# SI-161206

## **Service-Information Turbocharger**

### Technical modifications to the shield plate of the turbocharger

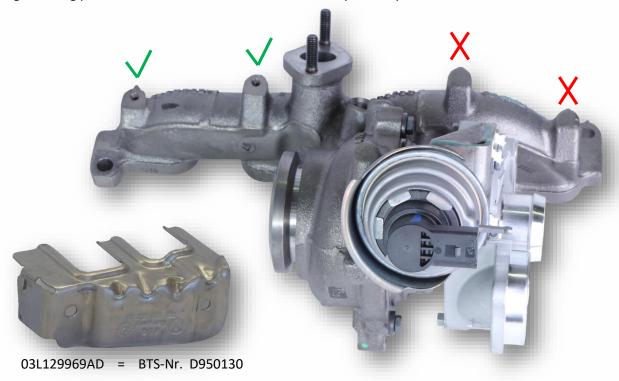
The vehicle manufacturer VW has made technical modifications to the shield plate, which is mounted on the exhaust manifold of the turbocharger.

Vehicles up to production date 15.11.2010 were delivered with a long shielding plate over all 4 cylinders of the exhaust manifold. Vehicles after 16.11.2010 were manufactured with a shortened shielding plate over the first two cylinders.

Therefore the turbocharger manufacturer has omitted the third and fourth threads for mounting the shielding plate since 01.07.2014.

If a long shielding plate 03L129969P is installed, this is to be replaced by the short variant 03L129969AD.
